## ORIGINATION FORM

Proposed Revisions to a Standard Plans Index  
(Please provide all information — Incomplete forms will be returned)

Index Number: 520-005  
Sheet Number (s): All  
Index Title: Concrete Shoulder Gutter Spillway

CONCRETE SHOULDER GUTTER SPILLWAY

DETAIL OF CONCRETE SPILLWAY AT END OF SHOULDER GUTTER  
 (TO BE USED WHERE INLETS, PIPES & ENDWALLS ARE IMPRACTICAL)

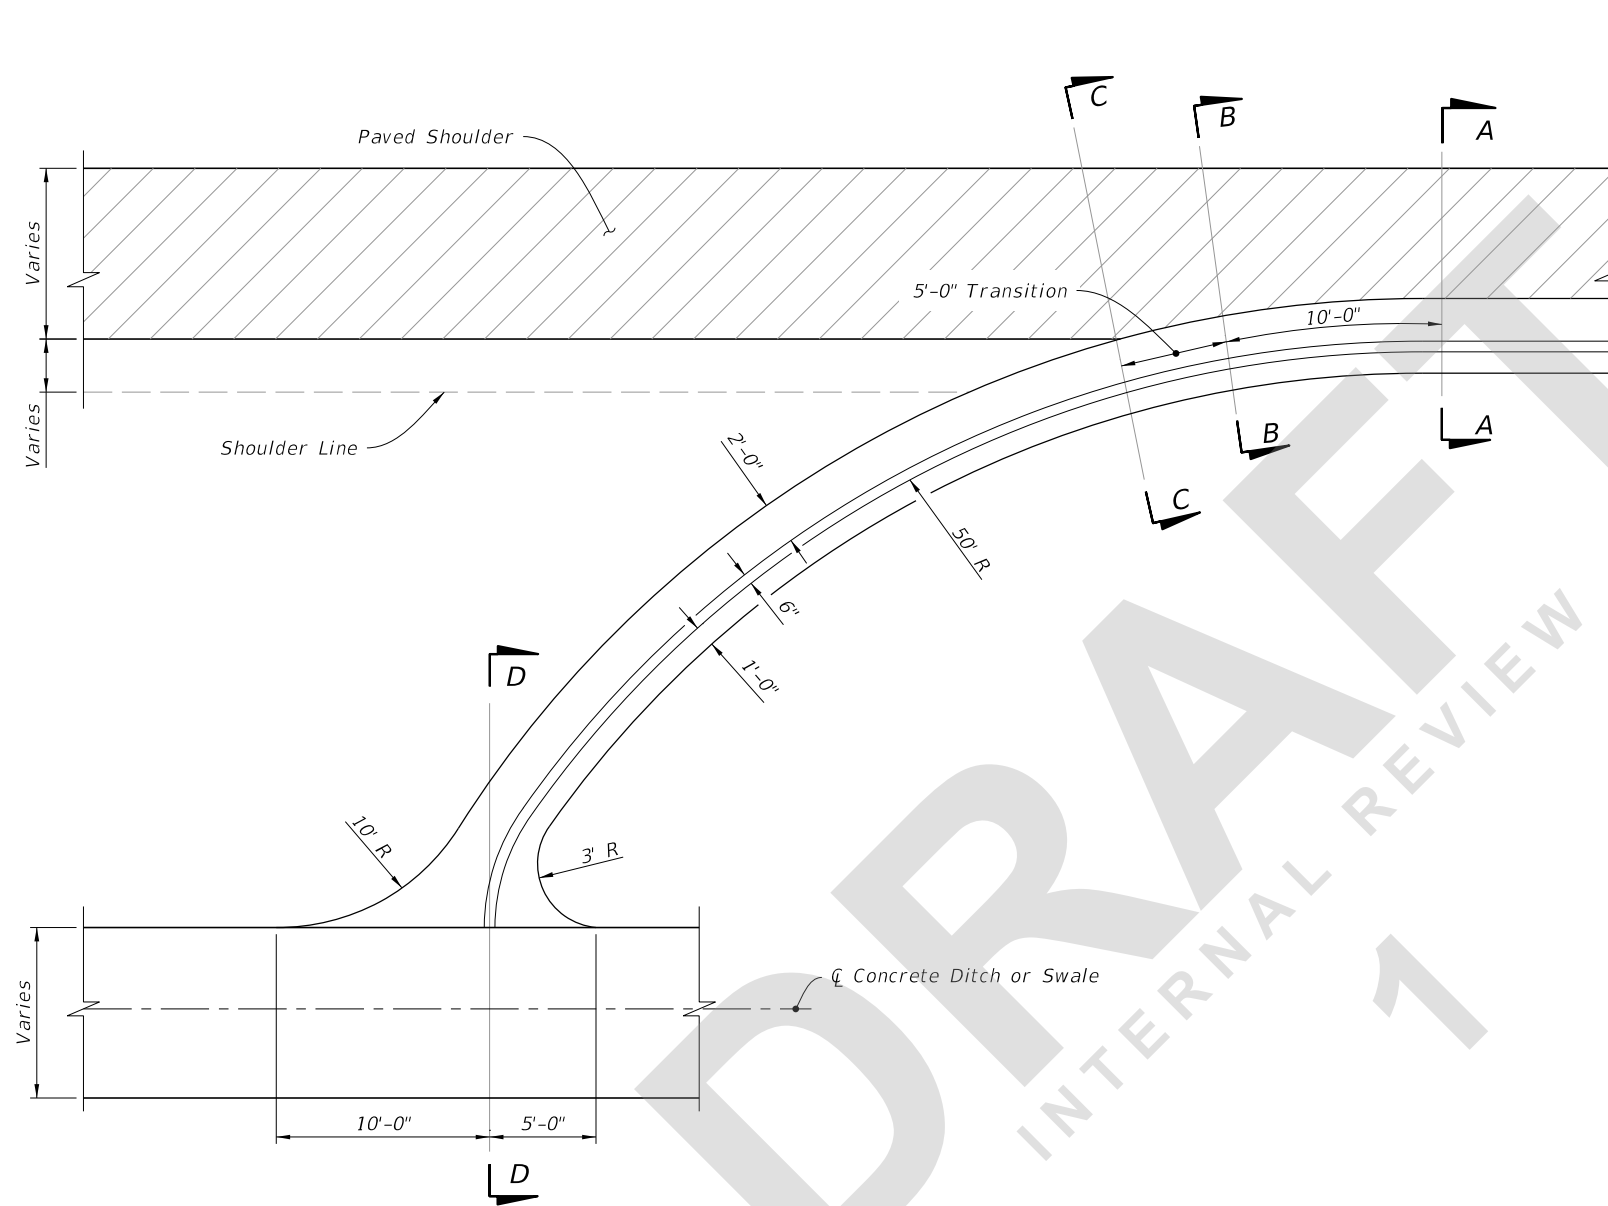
REDEVELOPED INDEX

- ~~1. Spillway to be paid for as Shoulder Gutter, L.F.~~
- ~~2. If spillway empties into an unpaved ditch, the detail should be modified as necessary.~~

Deleted notes; redrew details.

Redeveloped Index and deleted notes that are now covered in the SPI.
